# MELIADINE TYPE A WATER LICENSE

Public Hearings February 10-11, 2015, Rankin Inlet, NU

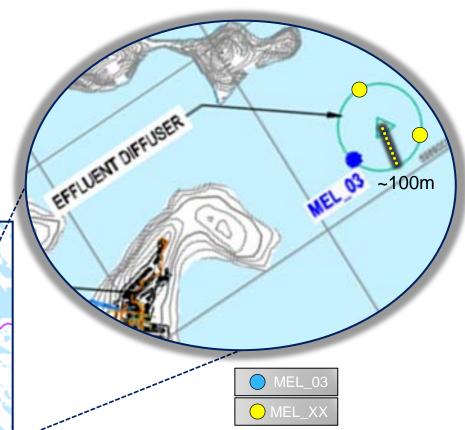
- We requested that AEM allocate 3 of the near-field exposure area sites around the diffuser to triangulate the predicted mixing zone boundary 100 m from the diffuser
  - i.e. sites at 120°, 240° and 360°, 100m from the center of the diffuser
  - Samples should be collected from the highest point of conductivity as determined by a water column profile
